City of Lakewood
Board of Building Standards • Architectural Board
of Review • Sign Review Board

MINUTES
BOARD OF BUILDING STANDARDS/
ARCHITECTURAL BOARD OF REVIEW/SIGN REVIEW

REVIEW MEETING
CITY OF LAKEWOOD
12650 DETROIT AVENUE
AUDITORIUM
July 9, 2026
5:30 P.M.

Docket No. 06-55-26 (13611 Madison)

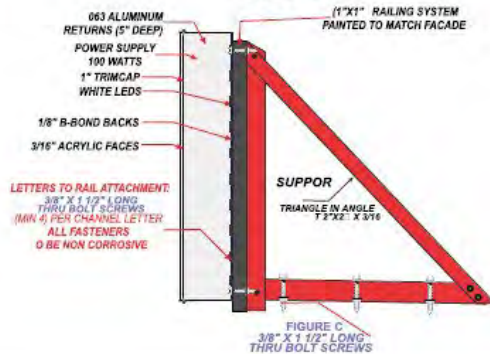
Shadi Almikdad, Neon & Signs, was present to discuss the plans. Mr. Almikdad stated what he was there to get approved and also stated that all the vinyl has been removed from the windows. The awning is now 10'X17" and within the allowable square footage. The Board had no objections and there were no public comments.

- 1) Approval is for the awning only, no window graphics
- 2) The awning signage will measure 10'x17"

Docket No. 06-57-26 (1655 Rosewood)
New Signage – Sunshine Enrichment Academy
Steven Foster

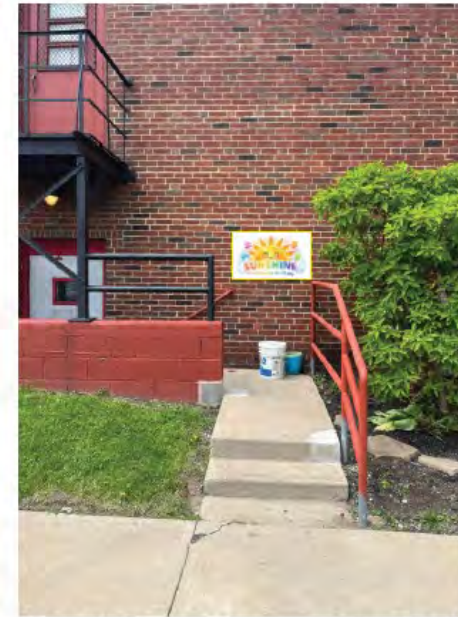
Steven Foster, The Sign & Graphics Firm, was present to discuss the plans. Mr. Foster discussed the removal of the rear entrance sign. Mr. Foster also requested that the rear entrance sign be included in the approval just in case it could be used in the future. The Board questioned the landscaping plan around the base of the ground sign. Mr. Foster stated that there is a landscaping plan in place and he would submit for administrative approval. No public comment.

- 1) Landscaping for the base of the ground sign be submitted to the Board Secretary for administrative approval

FRONT ELEVATION

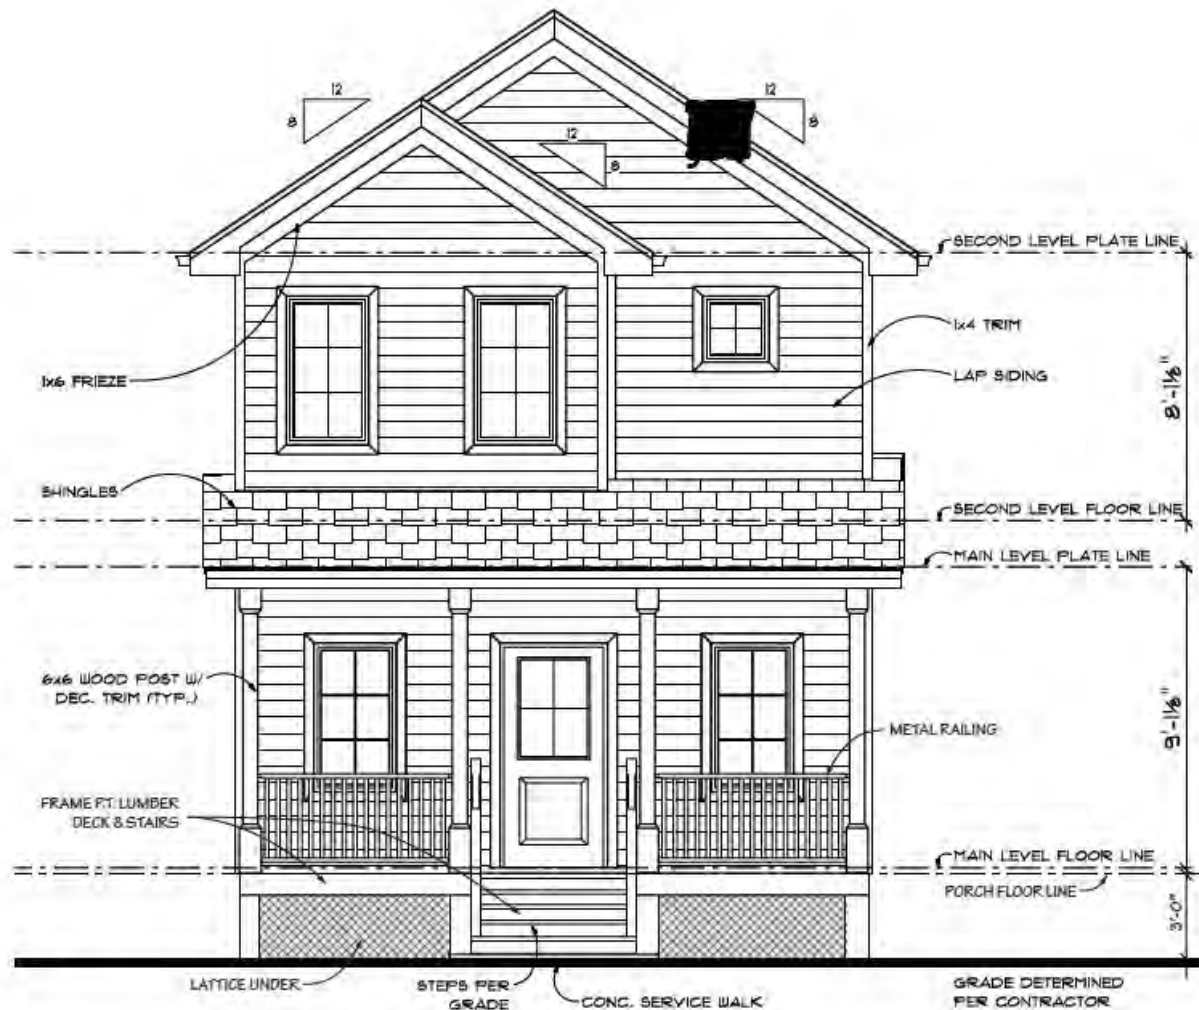
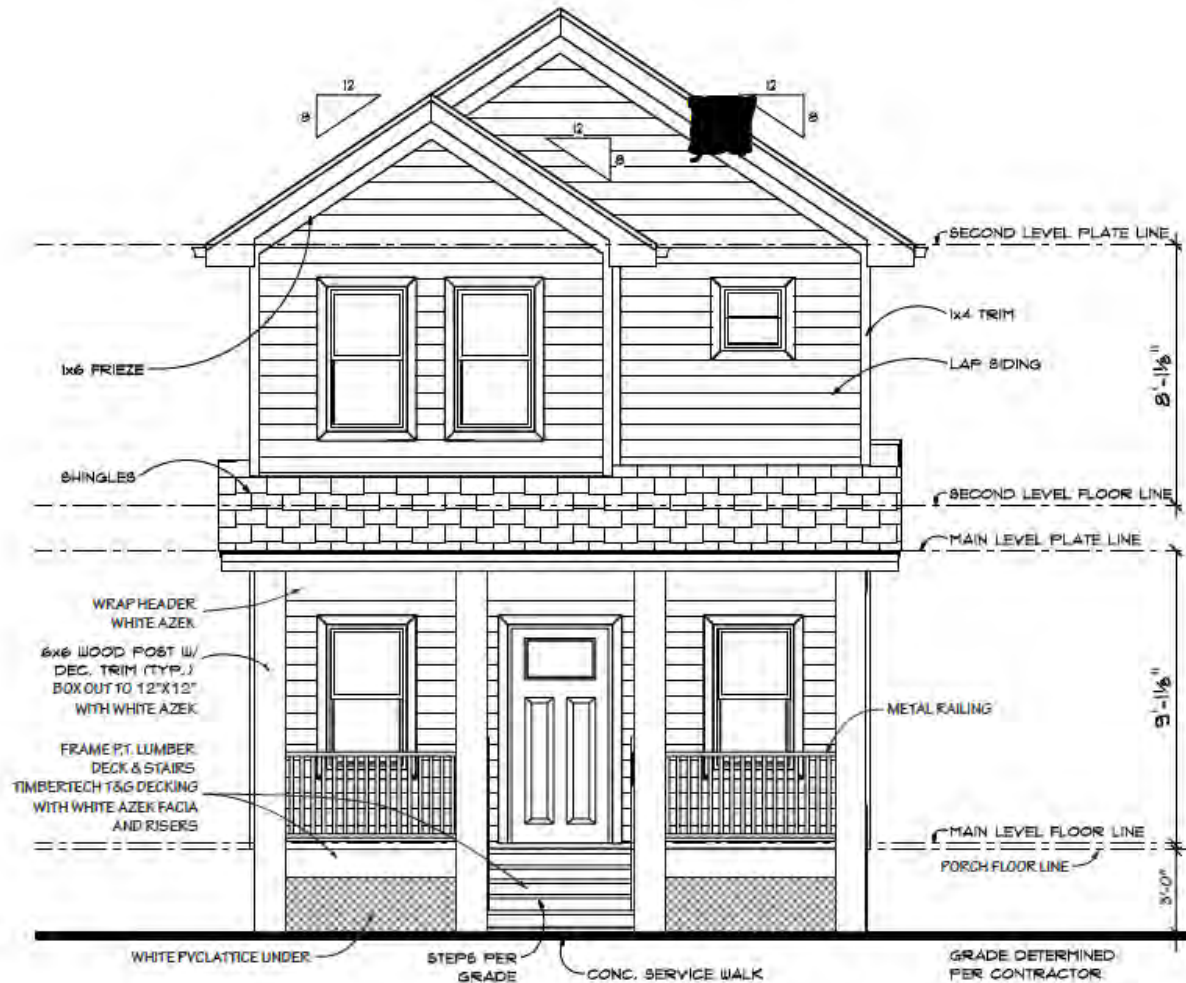
Farah Issa, The Hanna Homes, was present to discuss the updated plans. Mr. Issa stated that he made all the requested changes made by the Board at last month's meeting. He discussed the changes made in the sidewalk, mulch, pillars, porch, window alignment. He stated that the AC Condenser unit was moved to the other side as requested. He also talked about the windows on the left side elevation and how he would like them to be horizontal to allow for more wall space. Mr. Issa made a discussion on the types of windows being considered, Pava or double hung casement windows. He also requested that the porch have a standing seam, metal roof with concealed fasteners. Mr. Issa stated the doors are from Menards and there are product sheets already submitted. He discussed the use of Azek on the pillars, Azek white, 12 " diameter and the porch will be Timbertek along with the stairs. The Board discussed the windows on the left side elevation and how they would like to see the windows lined up between the two floors, if possible. The Board stated they are appreciative of the updates and they are supportive of the horizontal transom windows on the left side. The Board stated that the columns need to be updated, showing the beam running continuous across, and capitals at the base of each column. The drawings for the entire façade need updated and submitted. No public comment.

- 1) Double hung windows are included along with horizontal transom windows on left elevation
- 2) Option for standing seam with concealed fasteners on the porches after cut sheet and color is approved by Board Secretary
- 3) Revised front elevation with corrected beams and columns with capitals, submitted to Board Secretary for administrative approval

Docket No. 04-38-26 (1590 Coutant)

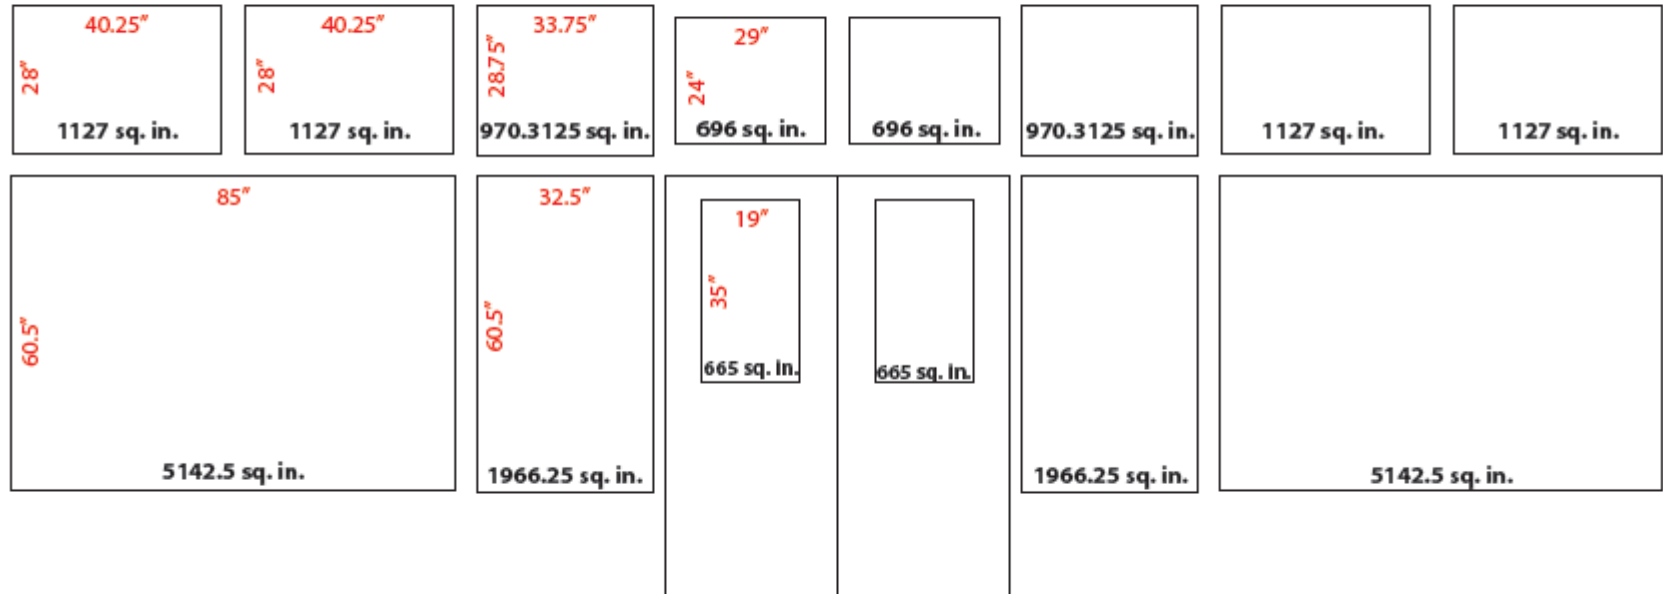
Dave Wenninger, FASTSIGNS, was present to discuss the updated plans. Mr. Wenninger stated that he removed some of the previous windows signs and stated that there is minimal graphics on the door. MR. Wenninger discussed the northern window sign with the graphics that are requested by Corporate. The window sign is 50/50 perforation and will cut down the sun exposure to not only his employees that work in that area, but also the equipment that is staged in that area as well. The Board stated that full coverage on the north side is a concern and would like to see the background of that graphic to be removed, that text only would be more approvable.

- 1) The background of the right window graphic be removed and only text shall remain.

BACK PATIO - SITE PLAN

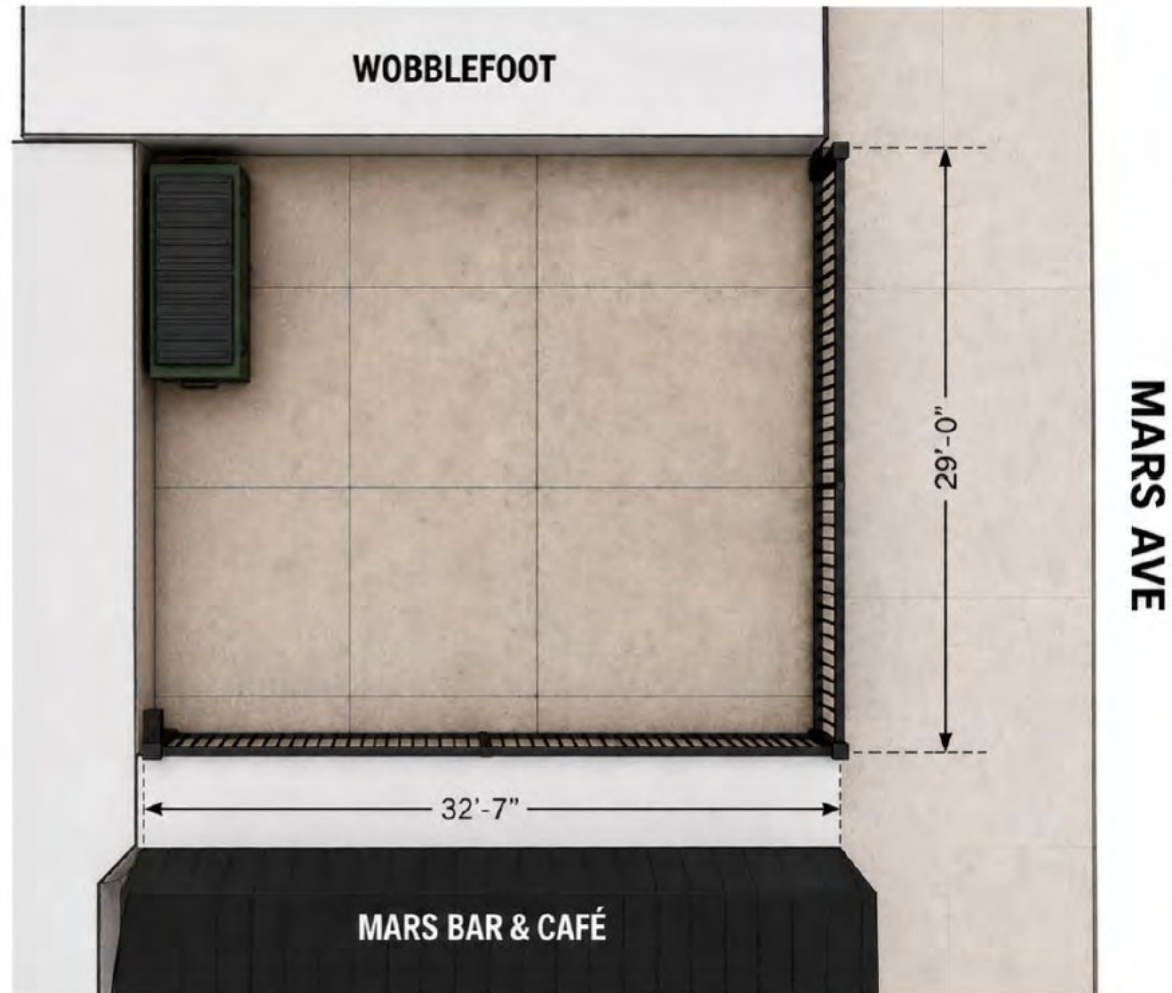
George Gountis, Mars Bar LLC, was present to discuss his plan. Mr. Gountis explained he wants to have a fence to enclose the back patio as well as an enclosure for the trash receptacles, inside the fenced in area. He stated that the gate would be motorized so the truck can get in and out easily when picking up the trash. Mr. Gountis also discussed that he would like to put planters in front of the fence along with lighting mounted on the fence. He explained that the fence would be an "L" shaped fence with a dumpster enclosure and it will be cedar and will be black. The Board stated that there needs to be cut sheets, and info for all the items; planters, furniture, lighting, gate. The Board also stated that the site plan needs to be to scale with the layout, how the new fence will work with the existing fence, and the fence construction detail. Cut sheets for the dumpster enclosure needs to be submitted also. No public comment.

Docket No. 07-69-26 (14224 Detroit)

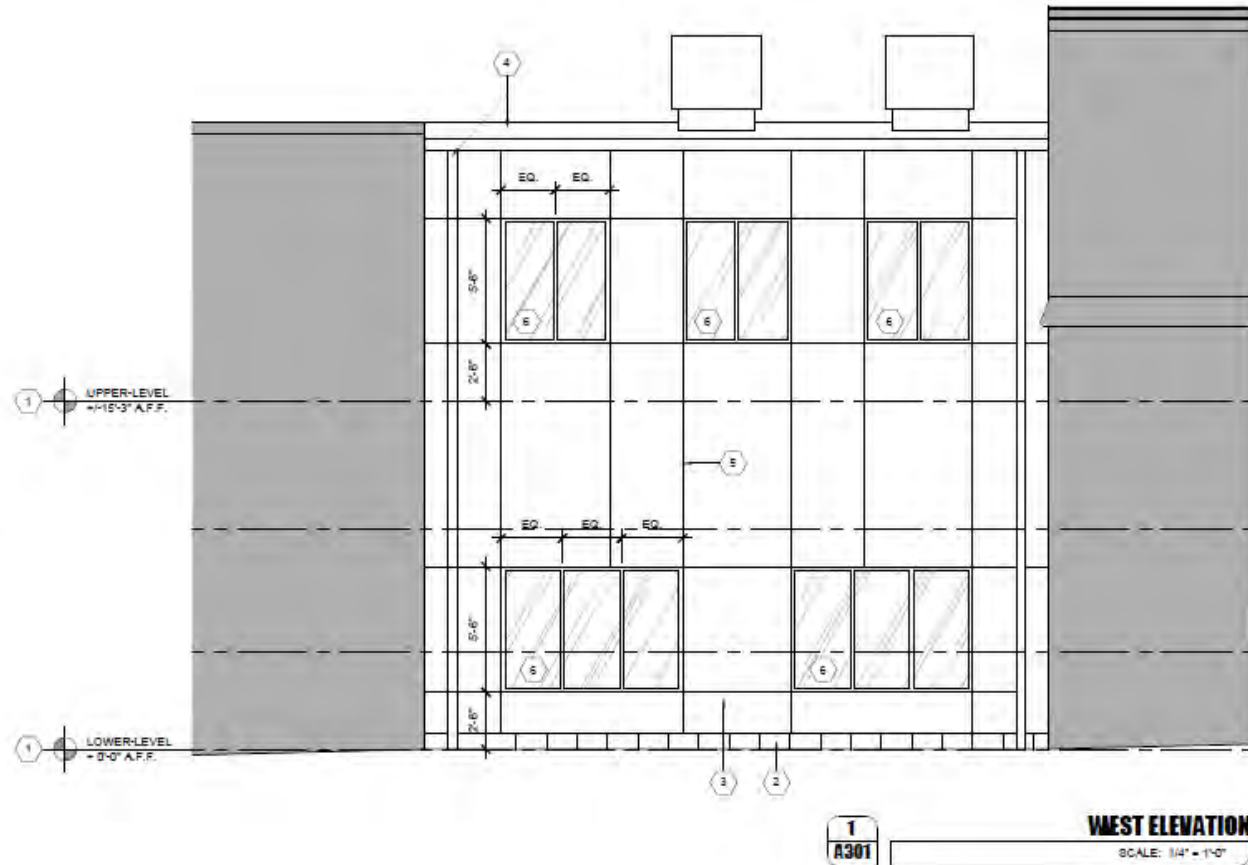
Greg Ernst, Found Design, was present to discuss the plan. Mr. Ernst stated that the roof will be sloping to the west and the courtyard will infill to the west. He also stated that they will be using smooth Hardie board with the J/U channel trim. Mr. Ernst also stated that the window color will be clear anodized to match the rest of the church building, you will not see the reveal lines, they will be flush with the panels. The Board stated that the elevation needs to be updated noting the updated color of the windows.

- 1) Window are clear anodized, not dark bronze. Send Board Secretary an updated elevation showing this.
